4. TITLE AND SUBTITLE
ALTERNATIVES ASSESSMENT OF INTERIM RESPONSE ACTIONS FOR OTHER CONTAMINATION SOURCES, M-1 SETTLING BASINS, ROCKY MOUNTAIN ARSENAL VERSION 3.1, FINAL

**FINAL ALTERNATIVES ASSESSMENT
OF
INTERIM RESPONSE ACTIONS
FOR OTHER CONTAMINATION SOURCES
M-1 SETTLING BASINS
ROCKY MOUNTAIN ARSENAL
NOVEMBER 1989
CONTRACT NO. DAAA15-88-D-0022/0002
VERSION 3.1**

**RESPONSE TO SHELL OIL COMPANY'S COMMENTS ON DRAFT FINAL ALTERNATIVE
ASSESSMENT OF INTERIM RESPONSE ACTIONS, M-1 SETTLING BASINS
NOVEMBER 1989**

Figure 1-2 - DECISION FLOW CHART FOR
INTERIM ACTION VERSUS
MONITORING/MAINTENANCE
ON HOT SPOT IRAs

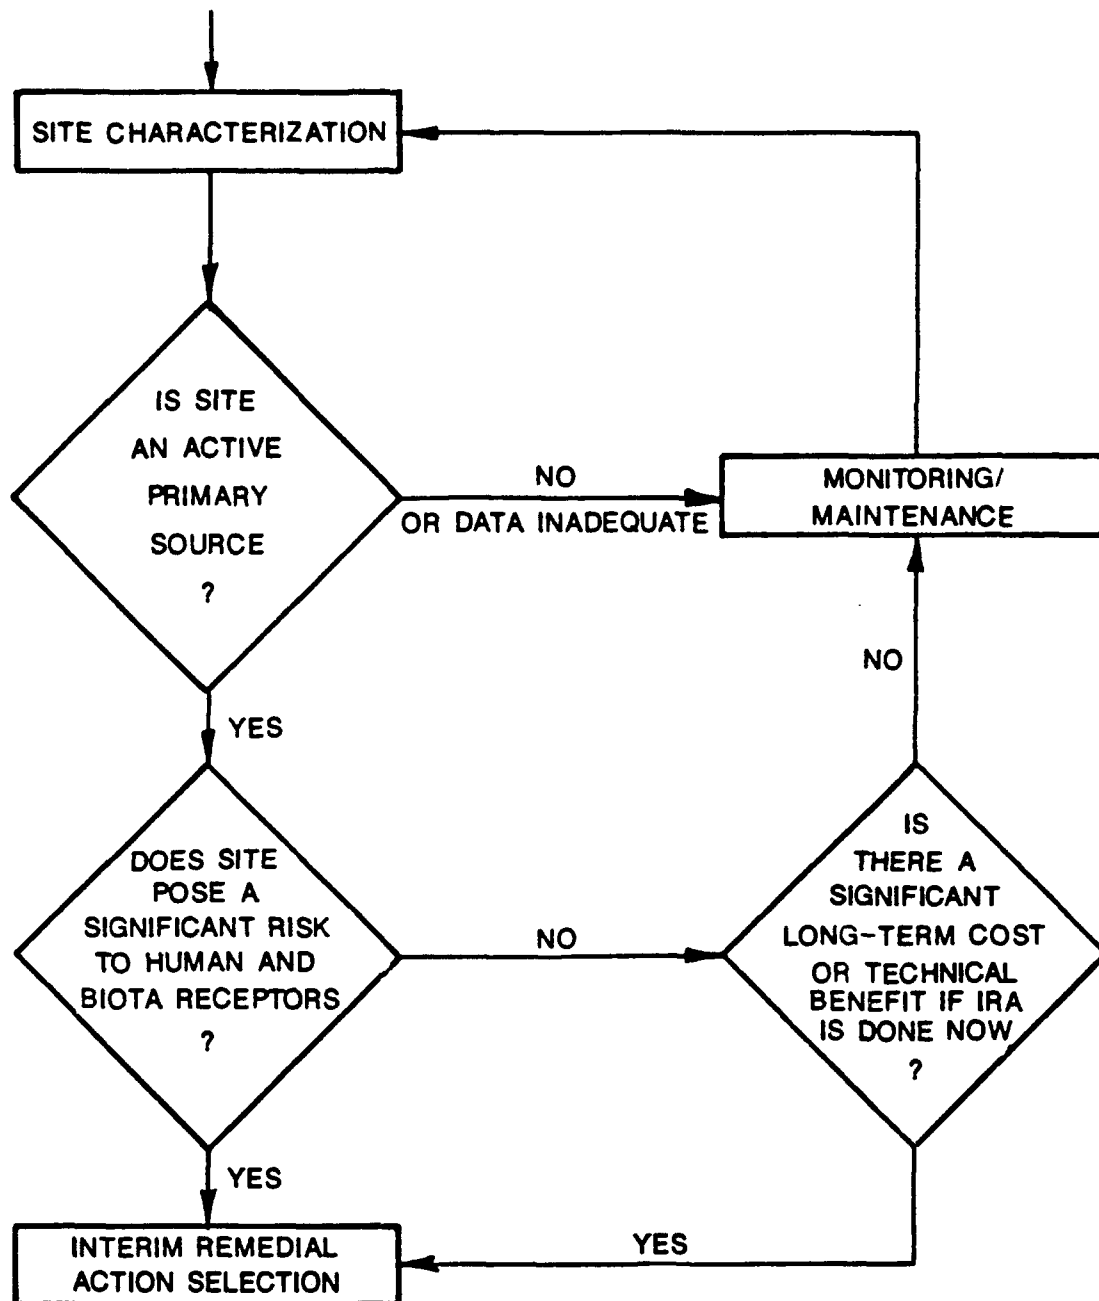
Comment 3: The Decision Flow Chart presented in this assessment (Figure 1-2) is an altered version of the Flow Chart actually agreed to by the Organizations and the State at the June 7, 1989 Other Contamination Sources Subcommittee meeting. Specifically, Data Inadequate should be on the NO leg of the first decision node, not on the YES node. The version agreed to is shown in Figure 1-1 of the final Technical Plan. This alteration appears to have misdirected this

Second, it was not agreed that if data are inconclusive or inadequate, a conservative approach would be taken. The agreement reached by the Organizations and the State in the June 7, 1989 Subcommittee meeting was that inadequate data would trigger the monitoring/maintenance action. Monitoring/maintenance may include further site investigation. The Decision Flow Chart in this assessment (Figure 1-2) is an altered version of the flow chart agreed to and which appears as Figure 1-1 in the Final Task Plan for Remediation of Other Contaminant Sources Interim Response Action. Specifically, the Data Inadequate decision path has been moved from

the NO to the YES pathway. Figure 1-2 of this assessment document should be replaced by the agreed to version. Data presented on this site are inadequate to assess the question of whether the M-1 Settling Basins are an active primary source of groundwater contamination. Accordingly, before proceeding with screening and evaluation of technology alternatives, further site investigation should be conducted.

Comment 1: Page 1-3 & 1-4 - The candidate selection criteria discussed on pages 1-3 & 1-4 do not accord with the flow chart presented as Figure 1-2. Specifically, the flow chart's initial diamond which presents the threshold question of whether the site is an active, primary source of contamination does not limit that question to an assessment of the site's effect on ground water. Such a limitation was expressly disapproved by State representatives at the June 7, 1989 subcommittee meeting which was held to discuss screening criteria for the "other sources" IRA.

Figure 2-1 M-1 SETTLING BASINS
FIELD INVESTIGATIONS

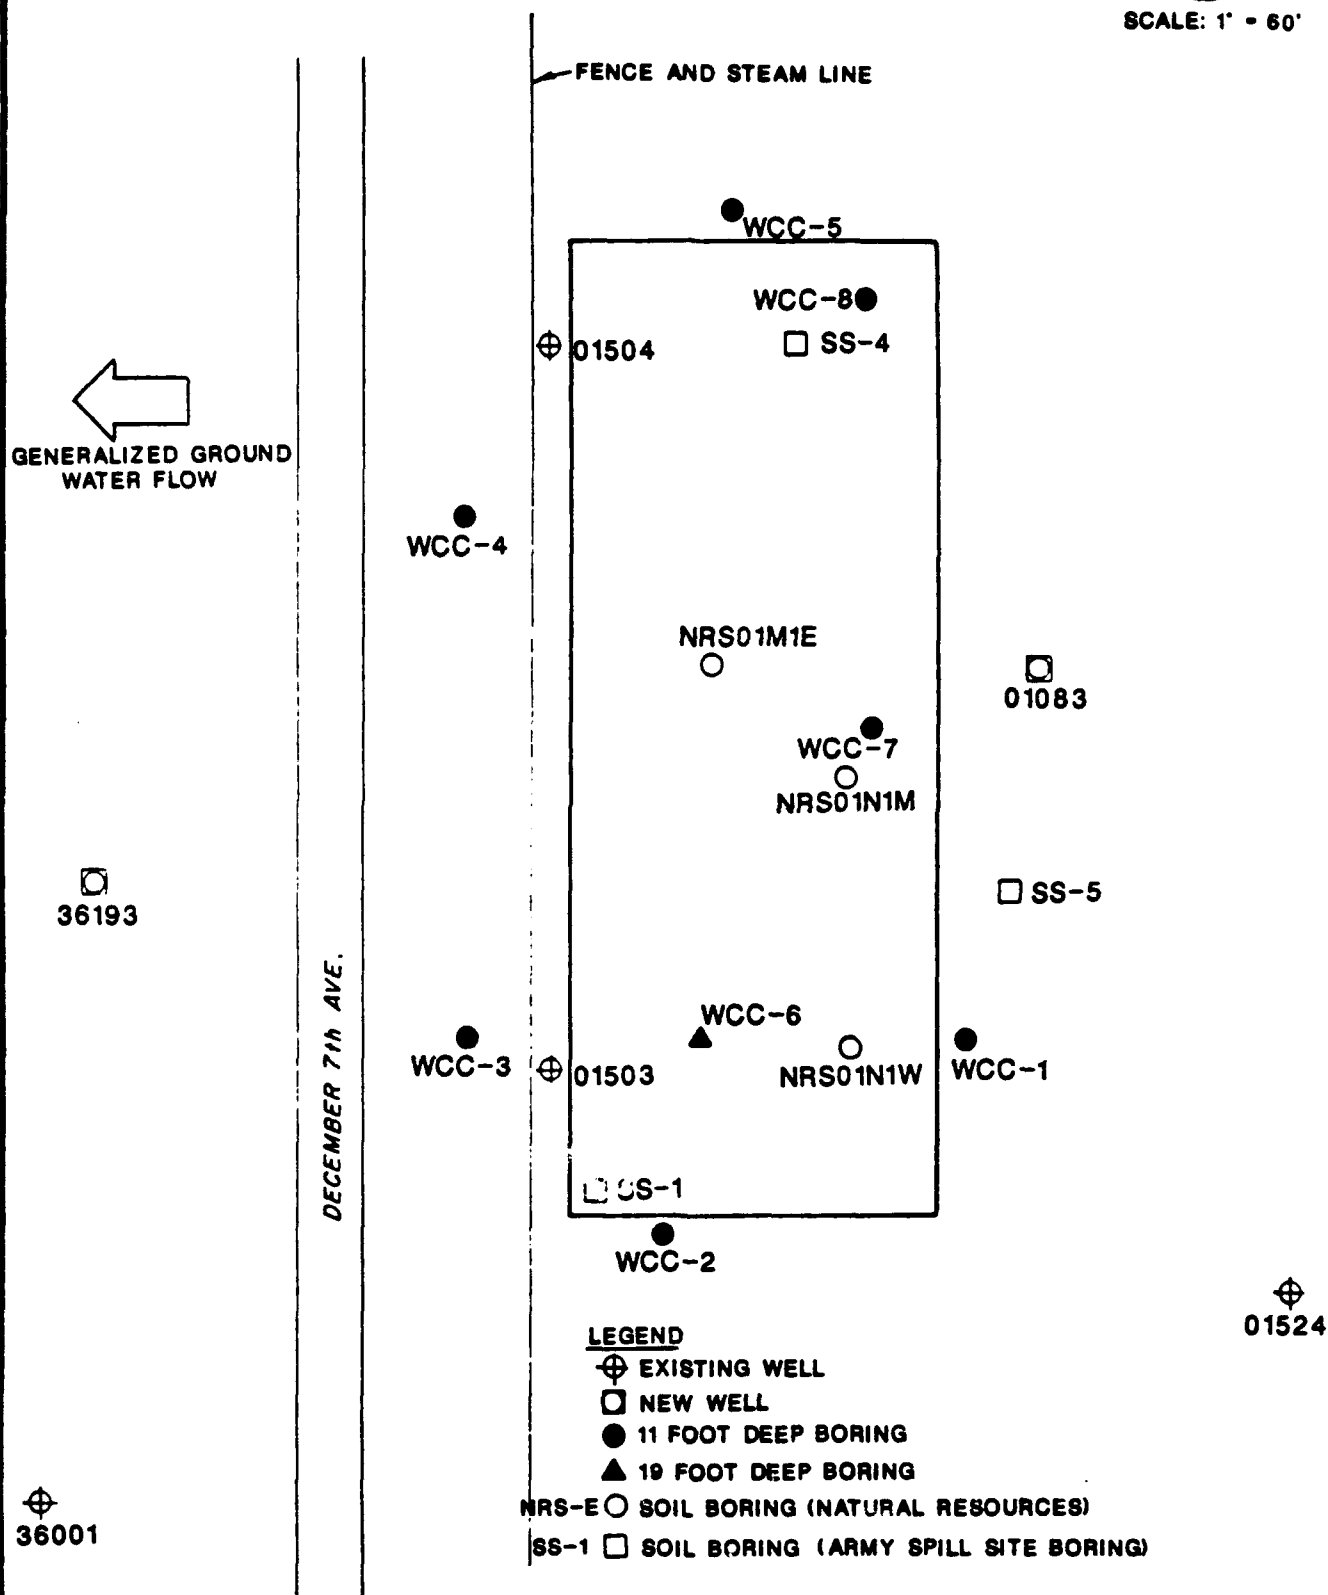
Comment 42: Figure 2-1, M-1 Basins Field Program.

B) The Alternative Assessment Document (page 2-4) states that six soil borings were completed in and around the perimeter of the M-1 Settling basins. However, the referenced figure (Figure 2-1) actually shows eight soil borings and there is no cross-referencing between the text and figure to clarify this discrepancy. The number system for the eight borings is also not consistent with the borings presented in the Army Spill Sites Report I (Plate 24S-1). Only three borings were completed in this study; two additional borings were not analyzed due to the presence of lewisite. Because basin perimeters are not marked on Plate 24S-1, it is difficult to determine coring locations with respect to the pits. However, it appears that only one boring (Boring 4) may have actually been completed within a basin. Nowhere in the text is there an indication that the bottom of any of the three basins was encountered.

(B) Figure 2-1 has been corrected to show the six soil borings drilled during previous investigations. Three were drilled during the Army Spill Sites investigation. The other three were drilled in 1986 and the data are in the RMA data base. The data from these borings are summarized in Table 2-1.
